MASTER DEVELOPMENT DRAINAGE PLAN & PRELIMINARY DRAINAGE REPORT

CROSSROADS NORTH

A RESUBDIVISION OF HILLCREST ACRES

Project #18-001
PCD Project #SP 20-207

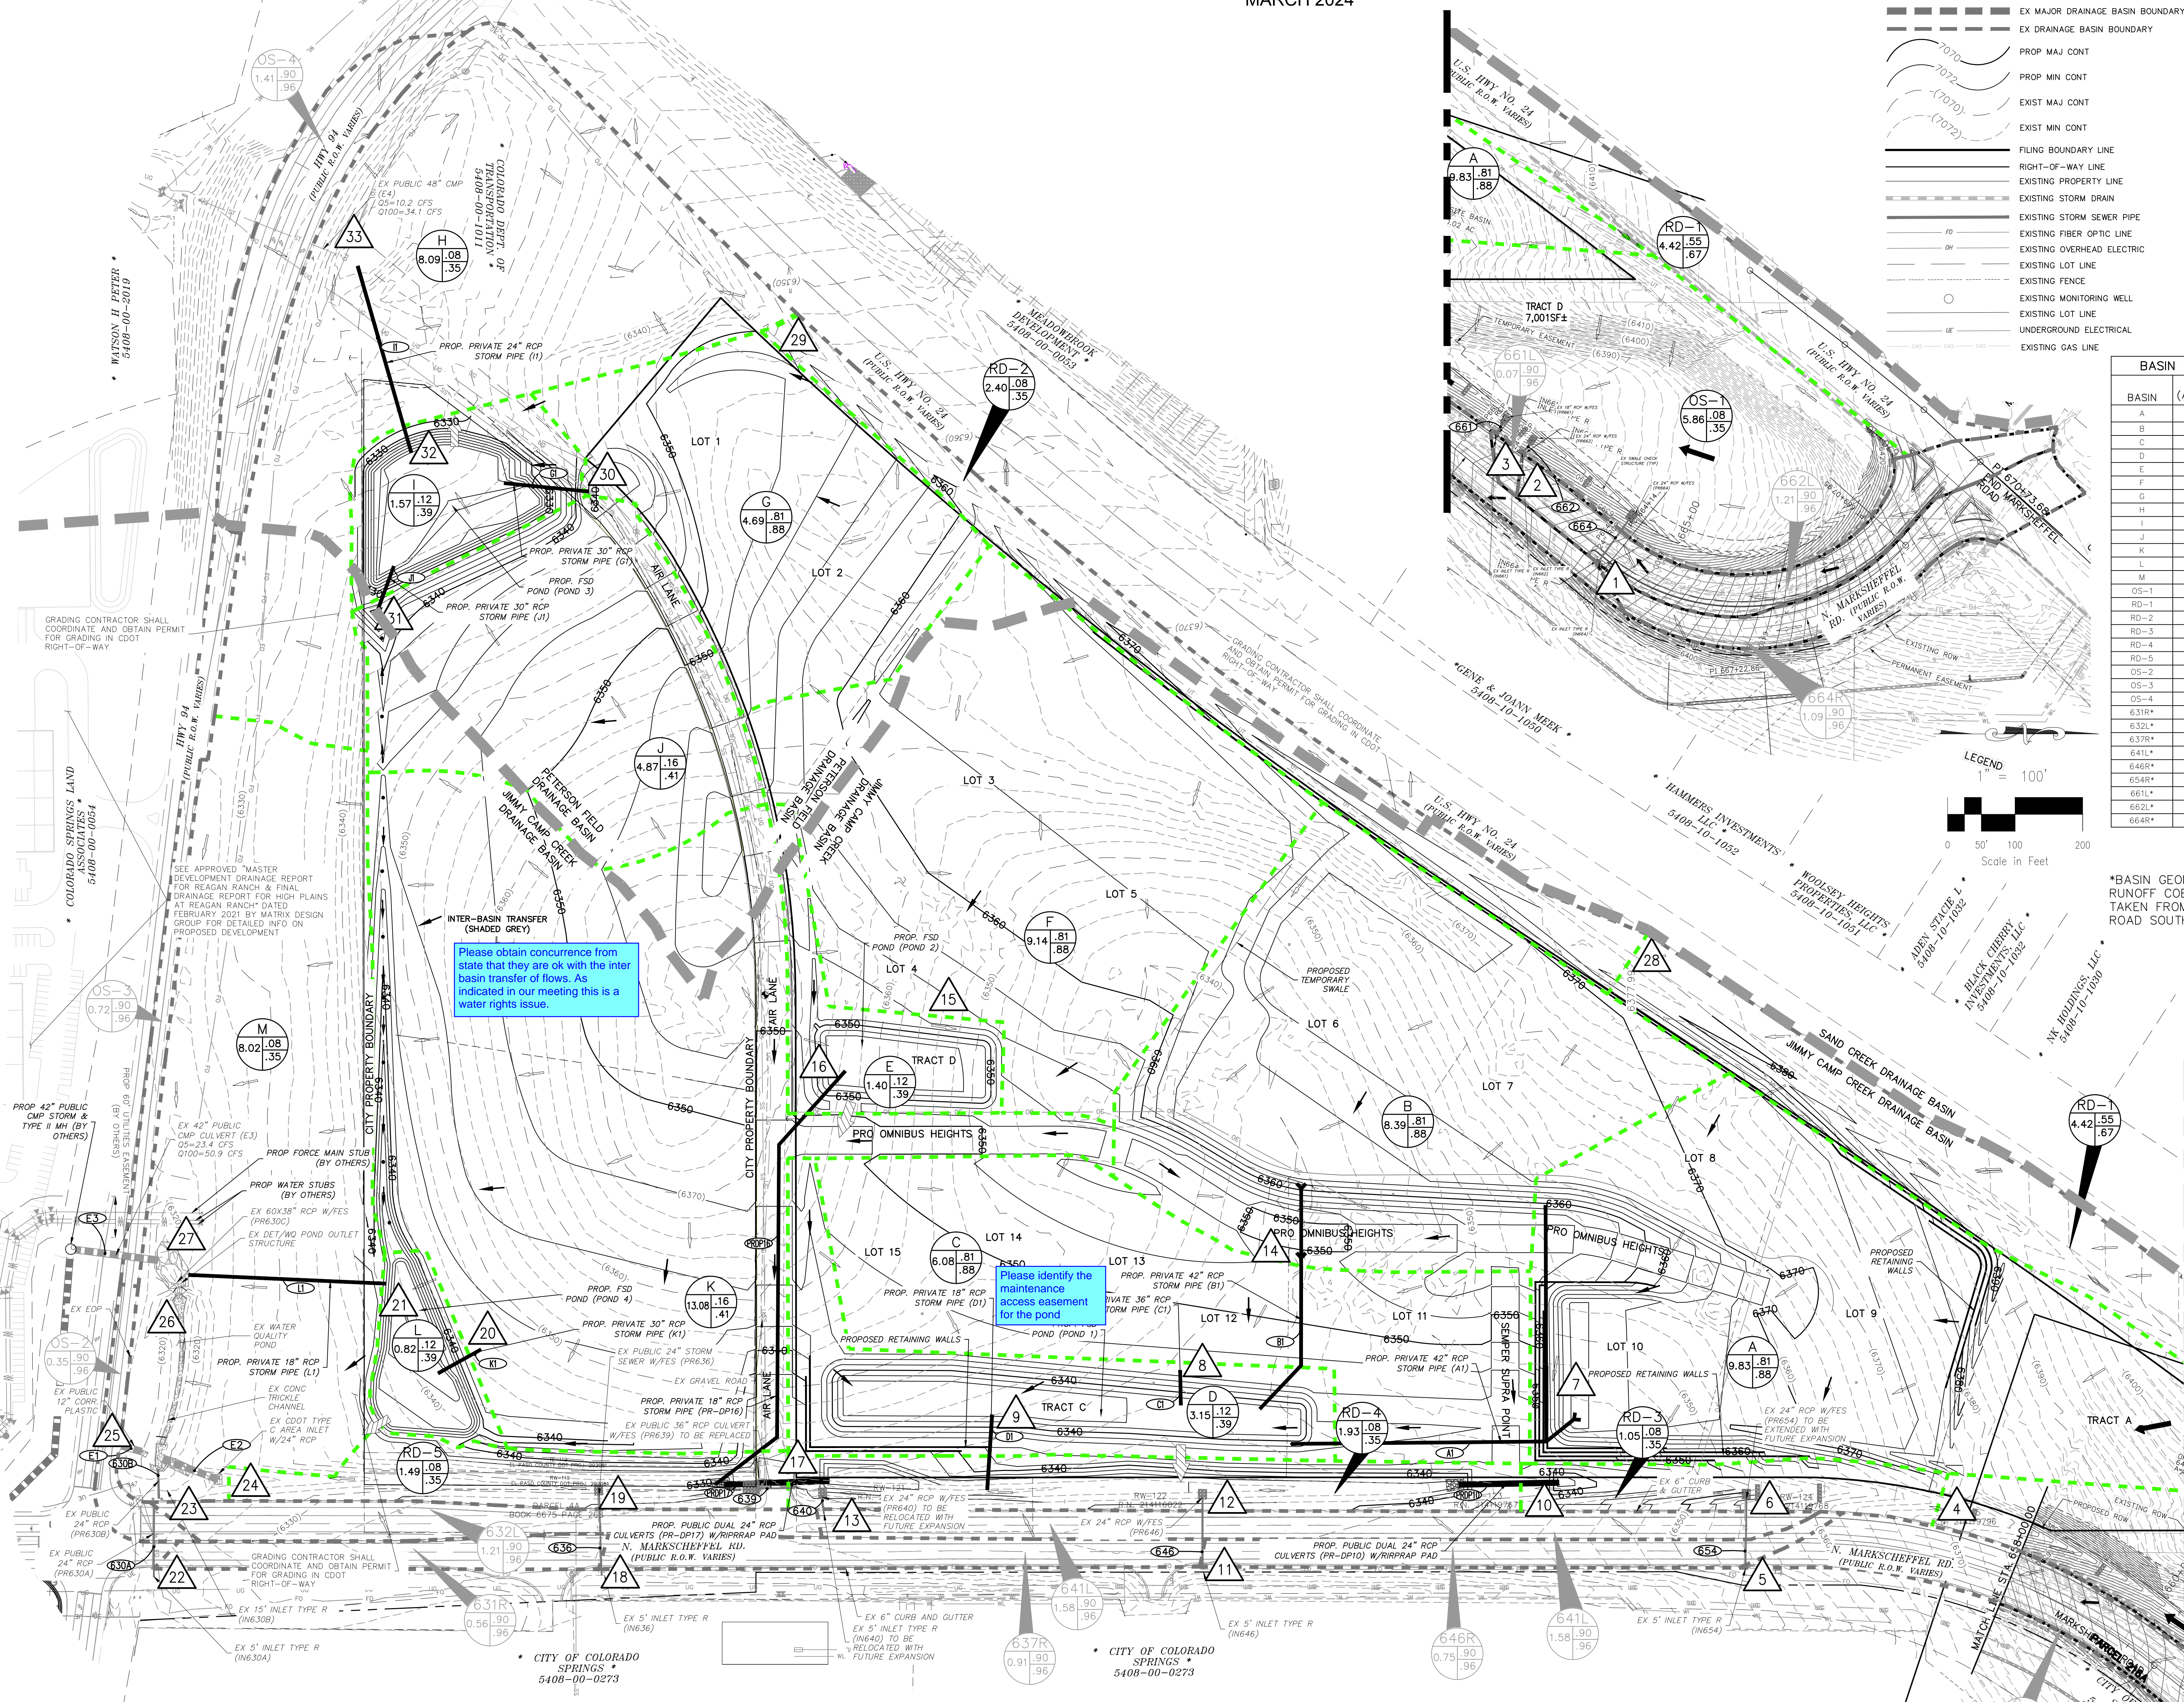
Please obtain concurrence from state that they are ok with the inter basin transfer of flows. As indicated in our meeting this is a water rights issue.

Please identify the maintenance access easement for the pond
